**PLANNED UNIT DEVELOPMENT  
& SUBDIVISION STAFF REPORT**

**Date: May 15, 2008**

Falling Leaf Subdivision

# SITE PLAN

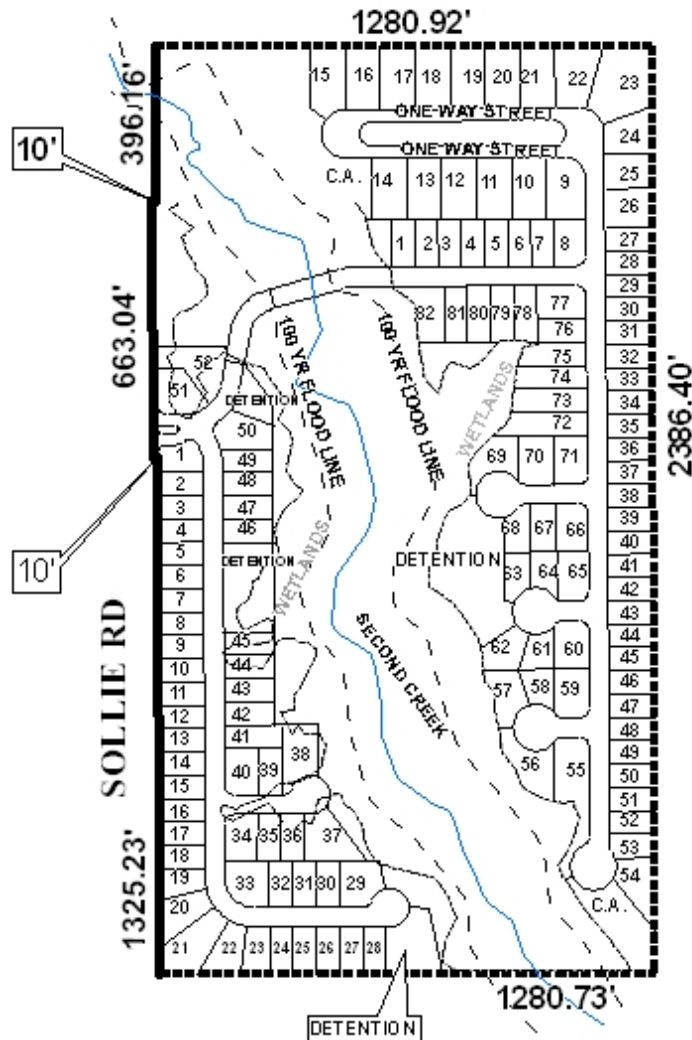
Sollie Road, which is shown as a major street on the Major Street Plan Map, has a variable existing right-of-way. The Major Street Plan requires a minimum right-of-way of 100' (50' from centerline). The plat illustrates an area that appears to be dedication to provide 50' from centerline where necessary; however, this area is not noted as dedication on the plat submitted.

Additionally, since Lots 8, 9, 56, 60, 61, 66, 67, 73, and 79 are corner lots, a note should be placed on the Final Plat stating they are limited to one curb-cut each with the size, design and located to be determined by Traffic Engineering. Labeling of each lot with its size in square feet, or provision of a table on the plat with the same information is also requested.

It appears that each lot meets the minimum size requirements for developments with access to public water and sewer. Due to the size of the proposed development, it is requested that the applicant revise the preliminary plat to provide the size of each lot in square feet on the plat, either as a table or as a label for each individual lot.

Several areas are shown on the preliminary plat along the Second Creek and between the one-way streets that should be labeled as common area, thus a note should be placed on the Final Plat stating that maintenance of the common area will be the responsibility of the property owners.

Also, as the application makes no reference to decreased setbacks or increased site coverage, all requirements of the Zoning Ordinance would apply. Further, no information was provided on the plat indicating the location of the proposed gate.

The applicant has submitted a revised plat identifying the 10' strip as dedication, bringing that section of Sollie Road into compliance with Major Street Plan requirements. The revised plat also illustrates the location of the proposed gate, which is well within the development and provides adequate vehicular turn-around within the site (a "u-turn" at the end of the proposed median).

1. dedication of 10' along the portion of Sollie Road as shown on the plat submitted;
2. placement of a note on the final plat stating that Lots 1-21, 51 and 52 are denied curb cuts to Sollie Road;

3. labeling of the wetlands, creek and detention areas as Common Area, and the placement of a note on the final plat stating that maintenance of all Common Areas and Detention Areas/Facilities shall be the responsibility of the property owners;

1. dedication of 10' along the portion of Sollie Road as shown on the plat submitted;
2. revision of the Final Site Plan to include placement of a note stating that Lots 1-21, 51 and 52 are denied curb cuts to Sollie Road;

3. revision of the Final Site Plan to include labeling of the wetlands, creek and detention areas as Common Area, and the placement of a note on the final plat stating that maintenance of all Common Areas and Detention Areas/Facilities shall be the responsibility of the property owners;

6. revision of the Final Site Plan to include placement of a note stating that standard setbacks and site coverage shall apply.
